ADDENDUM

NO. 01

PROJECT NAME: Littleton Springs Elementary School

ADDENDUM DATE: March 13, 2026

01 MASTER REFLECTED CEILING PLAN - LEVEL 02
1/16" = 1'-0"

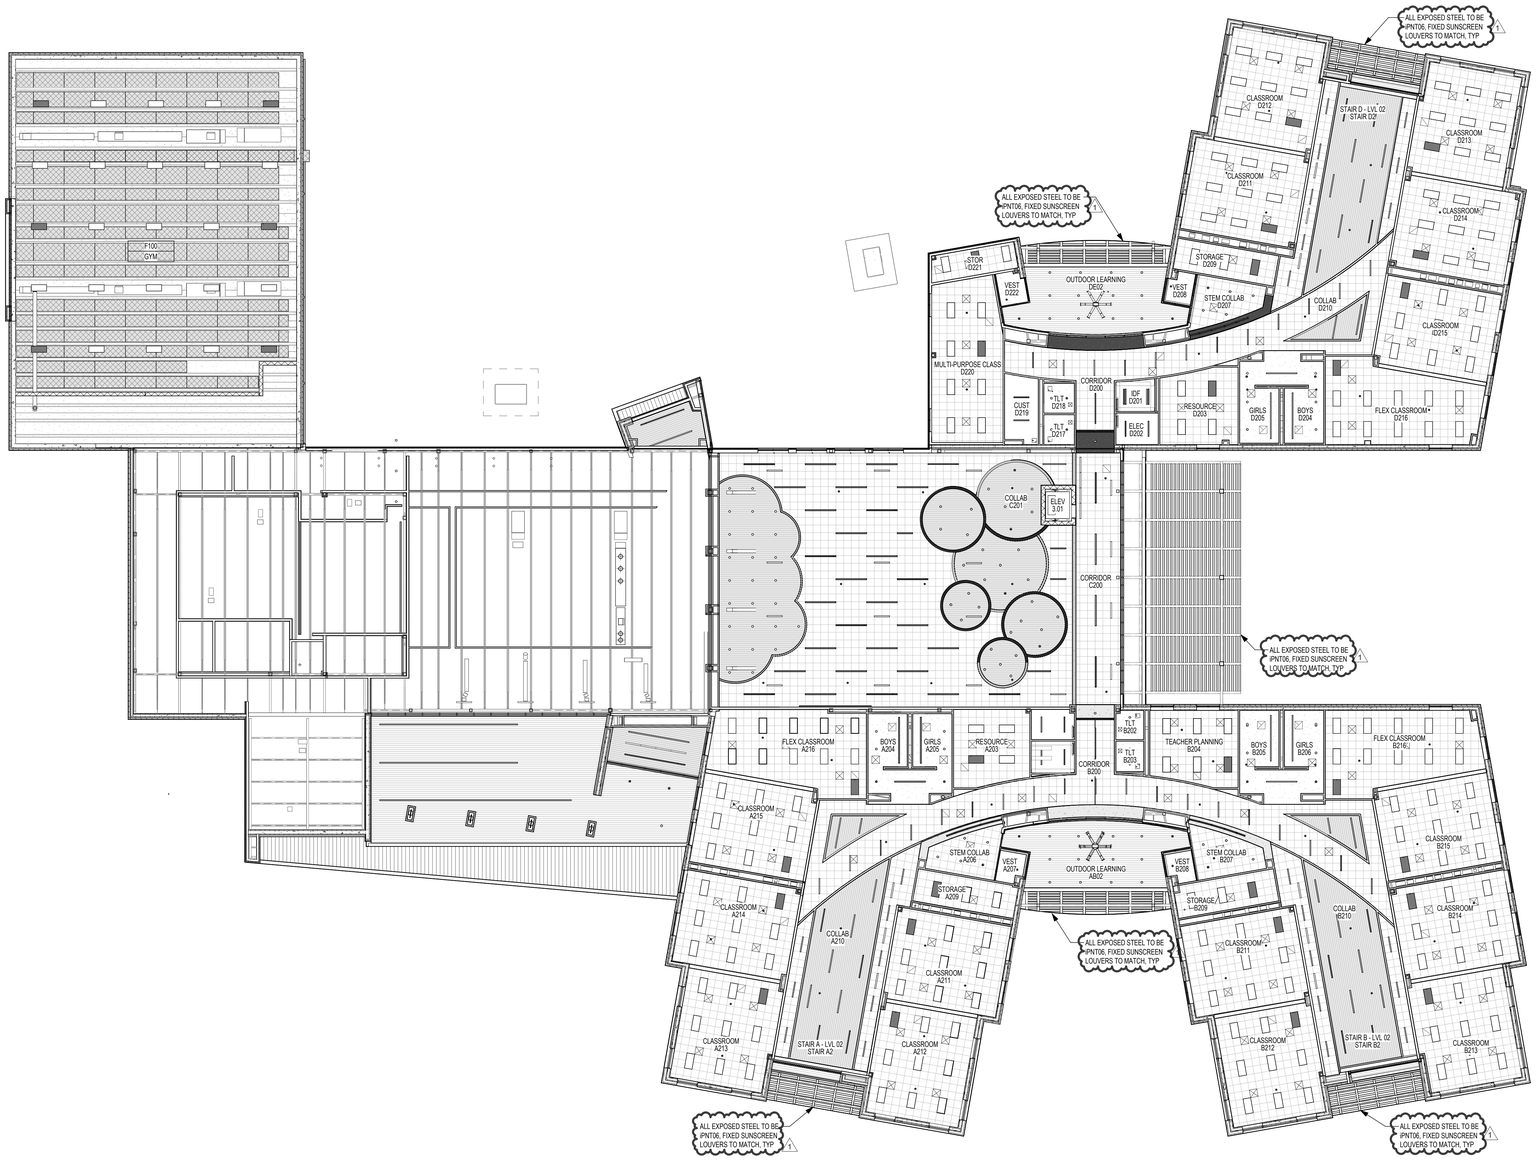
P2ADD 01, Arch Item 15: To the Drawings, Sheet A200.2 , "MASTER REFLECTED CEILING PLAN - LEVEL 02 ,"
Replace sheet in its entirety as issued per this PR, Revisions as follows:
1) Finish notes added to all Fixed sun screens

01 REFLECTED CEILING PLAN - AREA G - LEVEL 01
1/8" = 1'-0"

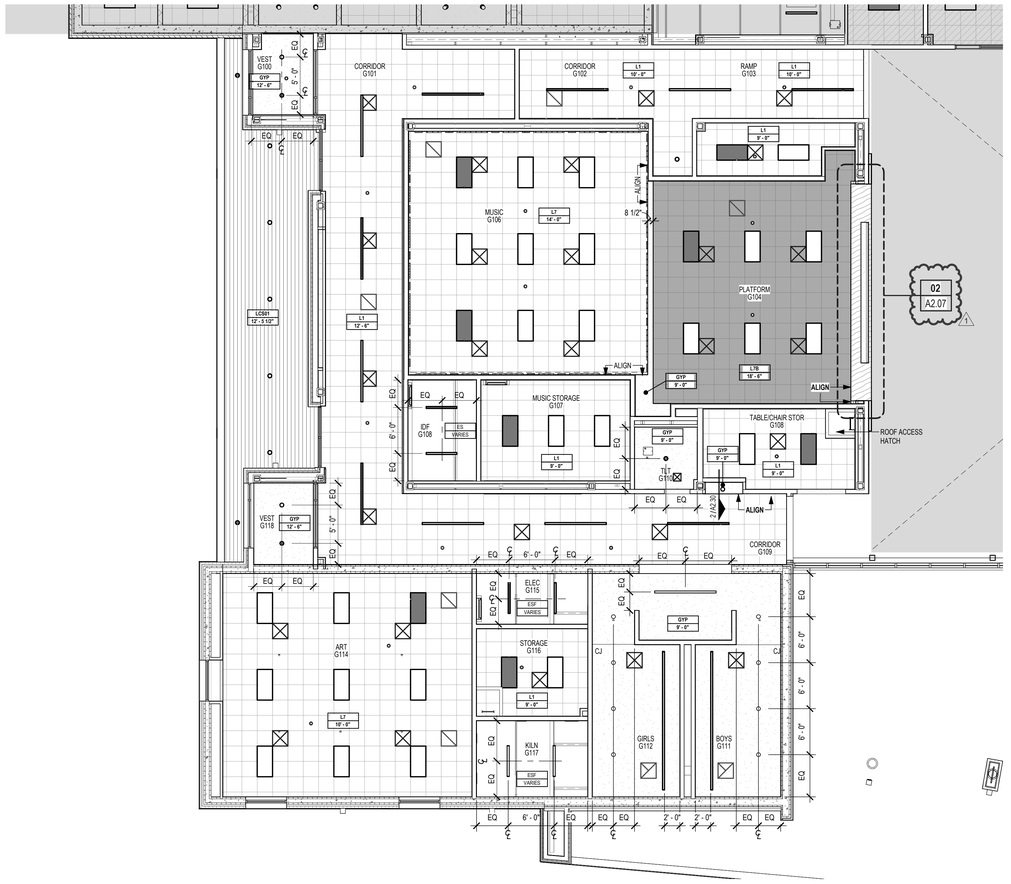
P2ADD 01, Arch Item 18: To the Drawings, Sheet A2.07, "REFLECTED CEILING PLAN – AREA G – LEVEL 01"

1) Add Callout 02/A2.07 at proscenium

Job No.	Sheet No.
1974-03-01	A3.02
Drawn By: GFH, KLK	
Date: 03/02/2026

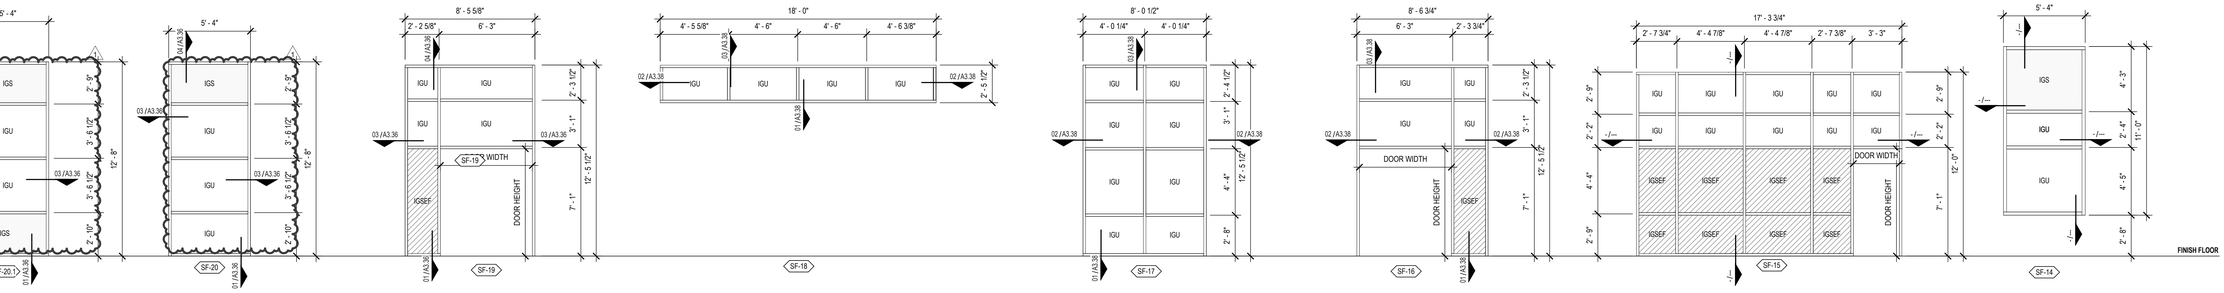
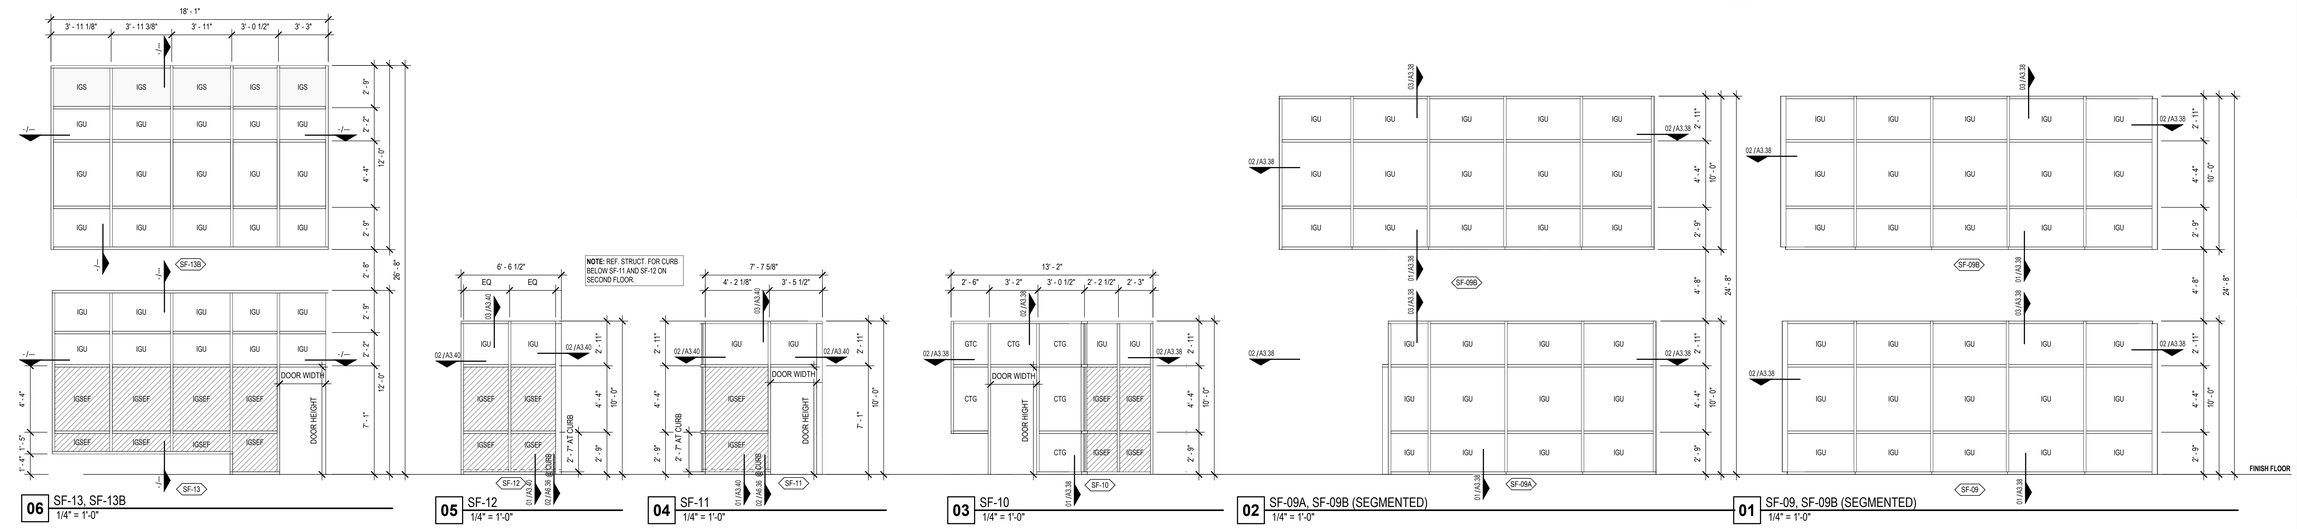
P2ADD 01, Arch Item 21: To the Drawings, Sheet A3.02, "EXTERIOR STOREFRONT CONFIGURATIONS"

1) Revise SF-20 mullion spacing
2) Revise SF-20.1 mullion spacing

01 FINISH PLAN - AREA A - LEVEL 02
1/8" = 1'-0"

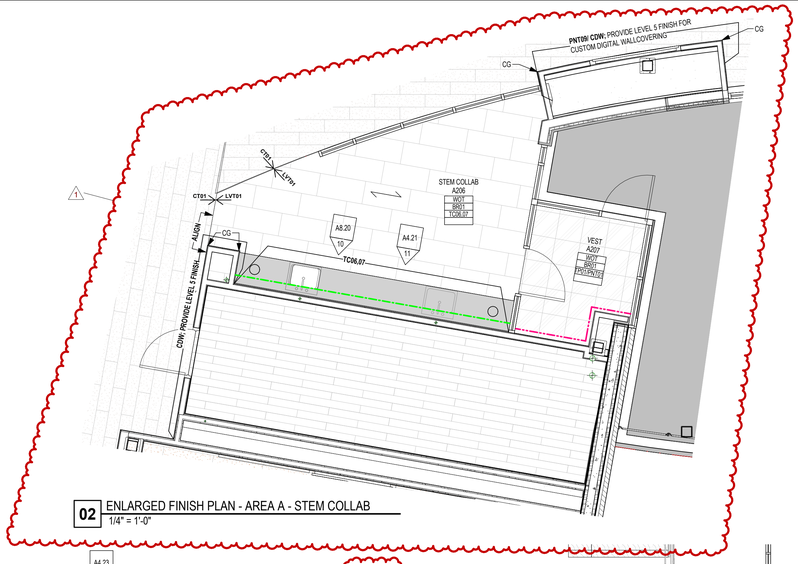
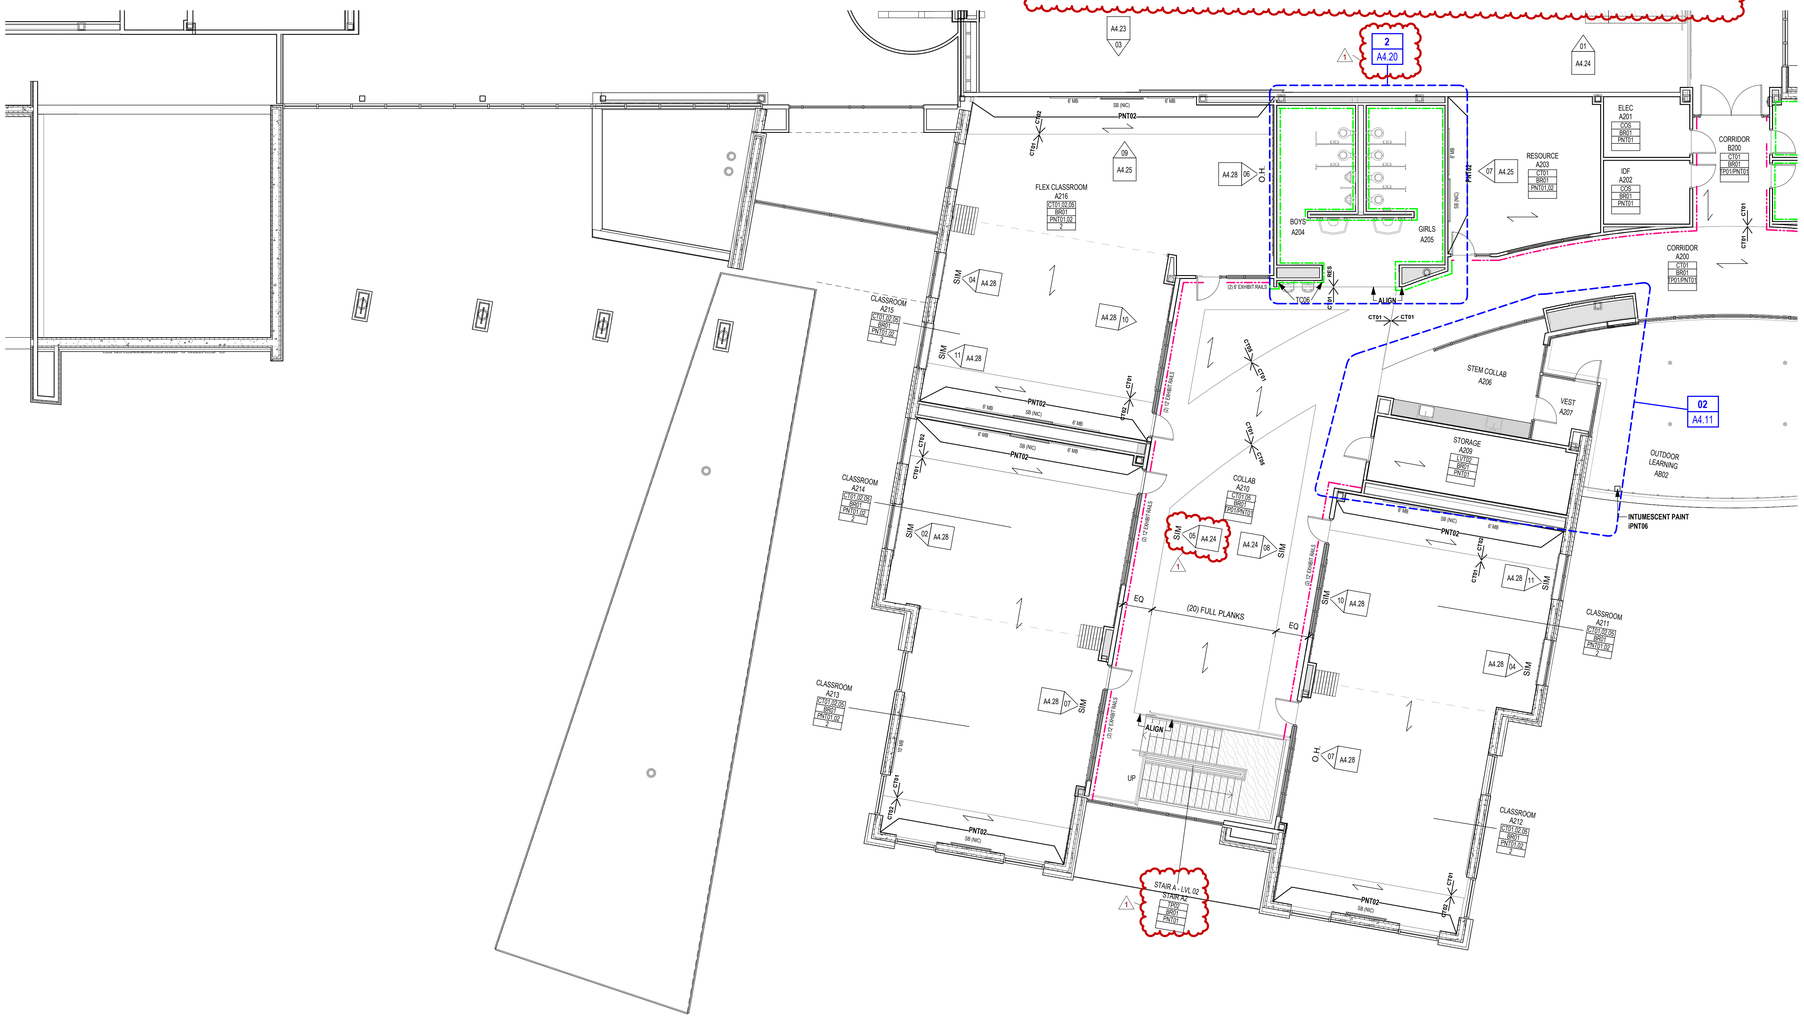
P2ADD 01, Arch Item 27: To the Drawings, Sheet A4.11, "FINISH PLAN – AREA A – LEVEL 02"

1) Update the extent of the enlarged stem collab plan to show entire location of wall graphics and corner guards.
2) Provide callout 02/A4.20 for group toilets for clarification.
3) Provide reference elevation in classroom collab space.
4) Update Stair A2 finish tag. Intent is for stair treads and risers to be TP02.
